RIGON **Technical Bulletin** No. RTB-001 SUBJECT: Service manual correction DATE:Nov. 15, '96 PAGE: 1 of 4 PREPARED BY: T. Itai FROM: 2nd Field Information Dept. QAC CHECKED BY: S. Fujii **CLASSIFICATION:** MODEL: AD1 Revision of service manual Information only ☐ Troubleshooting Retrofit Information Other

The following parts of the service manual have been corrected.

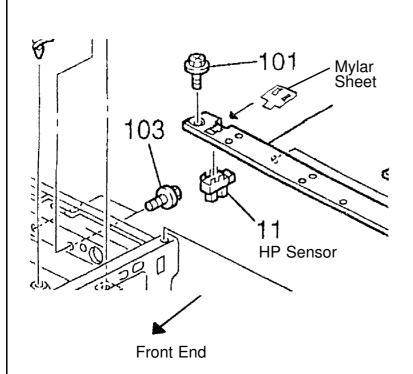
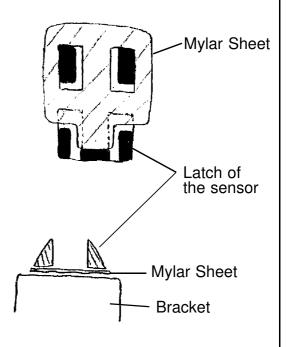
- 1. When the problem occurs, make sure that the sensor is properly fastened.
- 2. Insert the additional mylar sheet between the sensor latch and the bracket if necessary. (The part number is xxxxxxxxxx.) This mylar sheet has been incorporated into the production machines as follows.

How to set the mylar sheet:

Attach the mylar sheet as shown in the following illustration.

- 1. Attach the mylar sheet after the sensor is mounted on the bracket.
- 2. Make sure that the latch for the sensor is properly inserted through the hole in the mylar sheet.

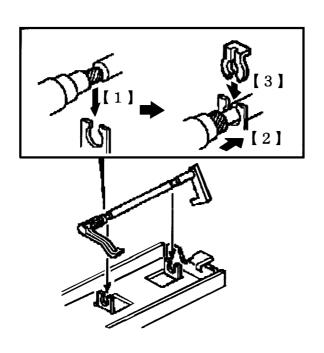
- 1. Set the thin part of the shaft (1 in the Illustration) into the holder.
- 2. Slide the paper end feeler to the rear and slide the wider part of the shaft into the holder (2 in the Illustration).
- 3. Put the snap ring on the thin part of the shaft.

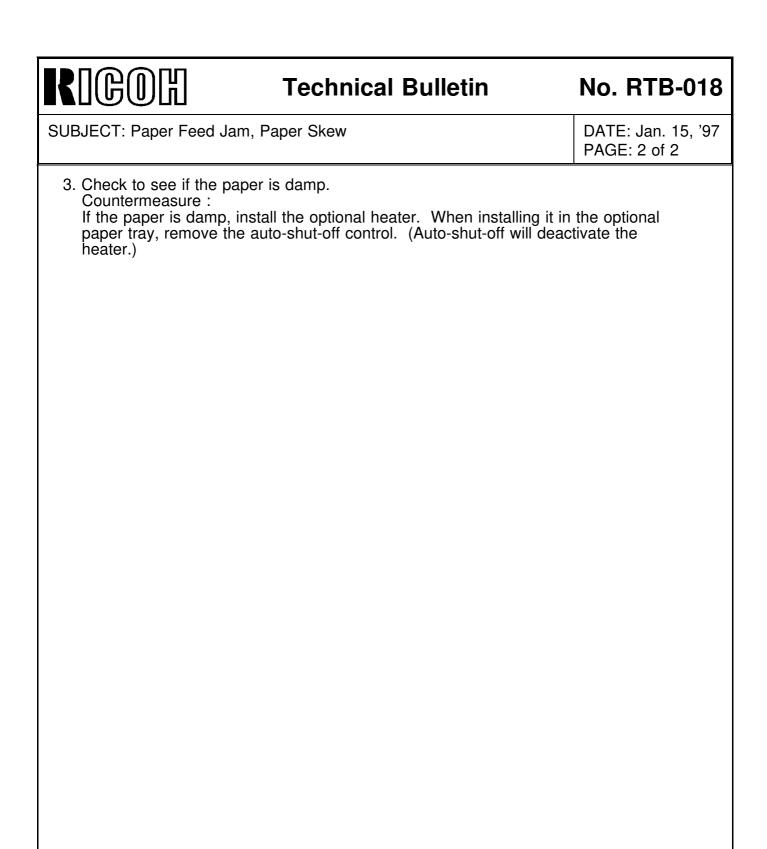
- 1) The overlap amount must be:
 - 5.7 ± 1.2 mm with the AD-1 Paper Tray
 - 6.0 ± 1.2 mm with the Optional Paper Tray
- 2) The difference in the amount of overlap between the front and rear of the corner separator must be within 1.5 mm.

If the overlap amount isn't within the above specifications, the corner separator may have been deformed. Reform the separator or replace if necessary.

Fig. 3

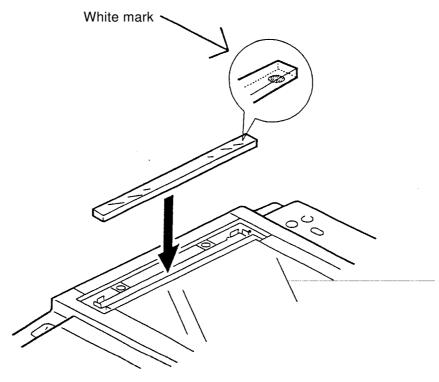
2. The surface of the exposure glass has been treated by the mater replant process.

Note: This exposure glass has a white mark. This mark must be at the bottom rear side at installation.

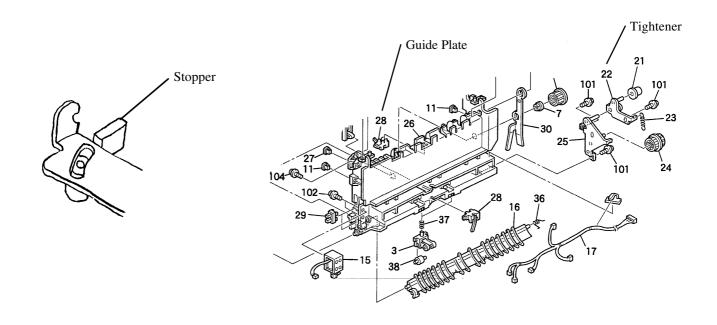
When the operator removes jammed paper from the exit of the transport section, the tightener (G0204333) will go over the boss on the guide plate (G0204409).

A stopper has been added on the guide plate.

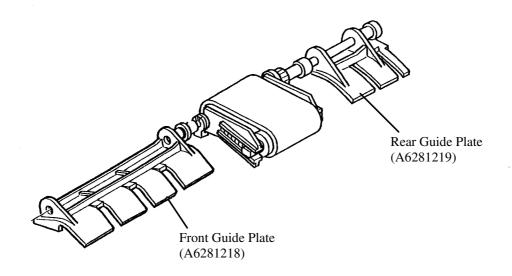
The color of the Front and Rear Guide Plates has been changed from black to a clear color.

Current	New
Front Guide Plate	A628 1218B	A628 1218C
Rear Guide Plate	A628 1219B	A628 1219C

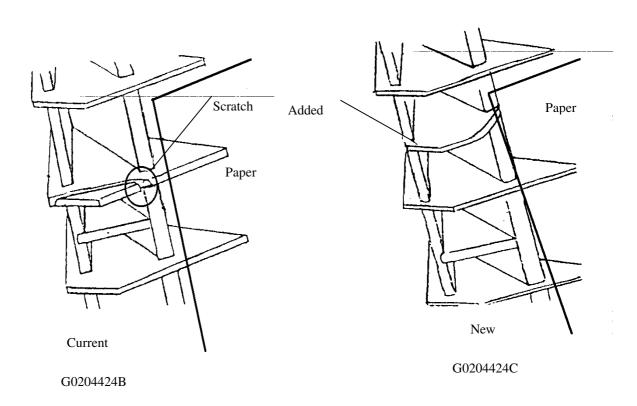
Legal size paper jam with the finisher.

A rib has been added to the Junction Gate inside the Legal paper width.

4.INSTALLATION PROCEDURE

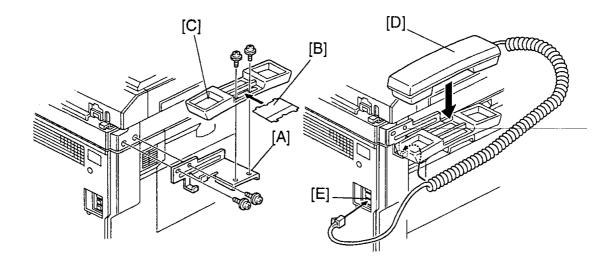
In some countries, the optional handset is available for the Aficio 200. To install the optional handset, use the bracket which is included in the Fax Unit Option, Type 250. Also, correct the installation procedure in the Service Manual on page 3-12 as follows.

- 1.Install the bracket [A] (2 screws), as shown.
 - * The bracket [A] in the carton box of the Fax Unit Option Type 250 must be used.
- 2. Remove the label [B] from the handset cradle [C]. Install the cradle on the bracket [A] (2 screws), then replace the label [B].
- 3. Install the handset [D] as shown. Connect the handset cord to the "TEL " jack [E] on the machine.

Figure 1

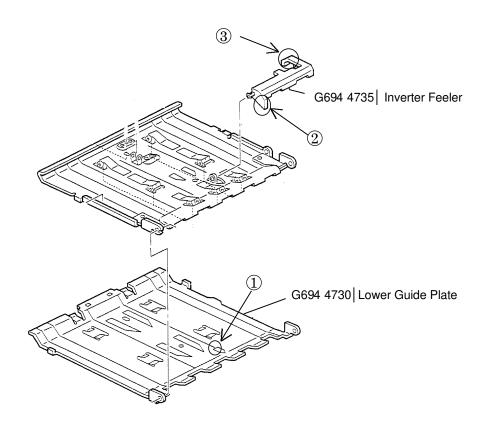
This moves component ③ of the Inverter Feeler closer to the Photointerrupter (AW020075). Then, the Inverter Feeler may often vibrate after the paper passes.

This may lead to the Inverter Feeler interfering with the signals from the Photointerrupter.

Figure 2

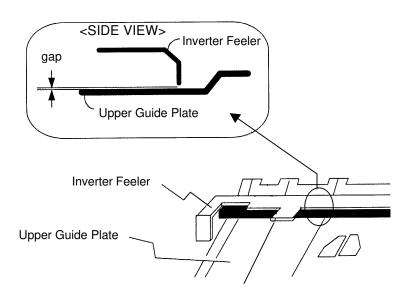
The Inverter Feeler normally rests on the Upper Guide Plate if it is free. Replace or reshape the Lower Guide Plate if you find a gap between the Inverter Feeler and the Upper Guide Plate, because the uplifted Lower Guide Plate has lifted up the Feeler.

- 1. Check the gap between the Inverter Feeler and Upper Guide Plate.
- 2. Remove the Snap Ring.
- 3. Remove the Upper Guide Plate.
- 4. Remove the Lower Guide Plate.
- 5. Attach the new or reformed Lower Guide Plate. (* See the next page.)
- 6. Attach the Upper Guide Plate.
- 7. Attach the Snap Ring.

Figure 3

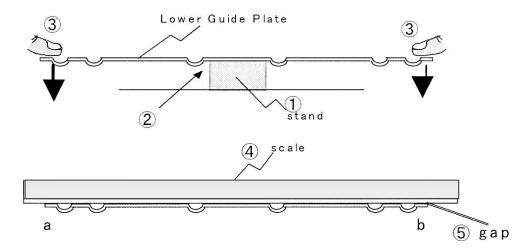
* How to modify the Lower Guide Plate.

- 1. Place the stand on a box-shaped object.
- 2. Put the center of the Lower Guide Plate face down on the stand.
- 3. Push both edges gently. **Caution:** If you push there too hard, the Lower Guide Plate will bend the other way.
- 4. Put a scale on the reshaped Lower Guide Plate.
- 5. Check the gap between the scale and the plate from a to b. If the gap is almost gone, the plate has been modified correctly.

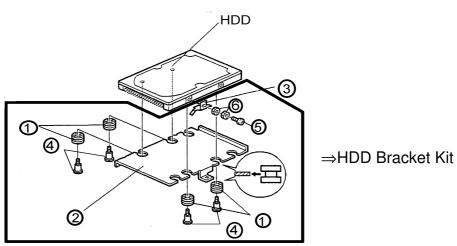
The HDD bracket has been modified for the print-overrun problem caused by vibration from the duplex unit (refer to RTB37). These new brackets have been available from June production in 1997 (the cut-in serial number is A7327060001-)

① AA161125 Bushing – HDD	4 pcs
②A1935840 HDD Bracket	1 pc
③A1935842 Grounding plate – HDD	1 pc
	4 pcs
©03130050B Philips Pan Head Screw - M3x5	1 pc
©07120030W Nut -M3	2 pcs
A6438612 Instruction Guide	1 sheet

If you have the print overrun problem on an AD1 with a duplex unit or when you visit a customer whose machine has the old HDD bracket, please change the bracket to a new type.

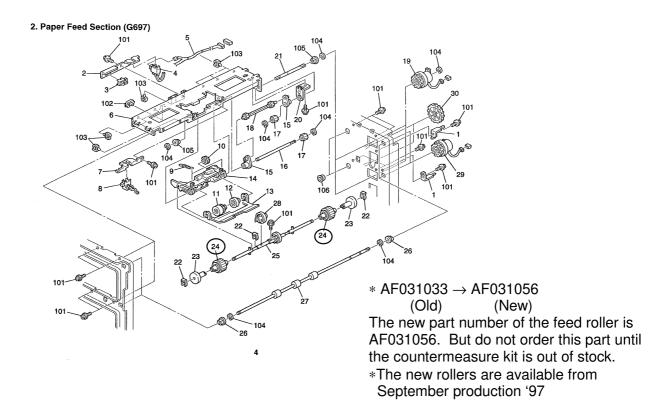
CAUSE: Paper skewing or no feed from PS330 (Paper Tray)

Countermeasure: The diameter of the paper feed roller has been modified from 30\$\phi\$ to

32\$\phi\$ to improve paper feed.

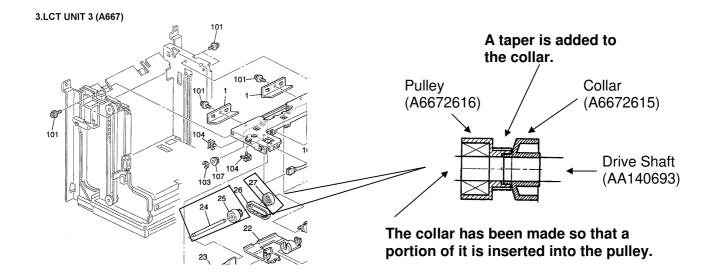
To prevent this problem in the LCT, the material of the shaft and the shape of the pulley and collar have been modified to reduce the dust from the timing belt and to prevent the dust from getting into the pulley. RCL will supply the countermeasure parts to each subsidiary.

1. AA140627 → AA140693 Drive Shaft – Feed Roller

2. H5154713 → A6672615 *Timing Pulley Collar – 6x8*

Permanent Countermeasure

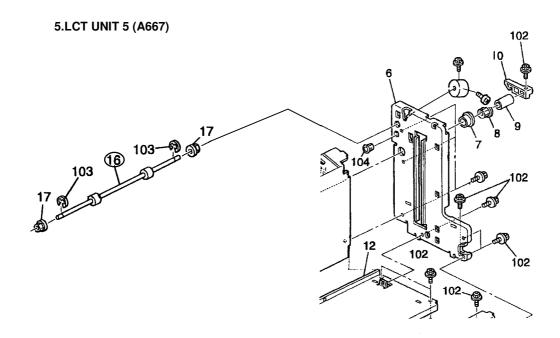
To reduce the rotation noise from the relay roller, a fly wheel is added to stabilize the rotation. The material of the shaft and the shape of the timing pulley have been modified.
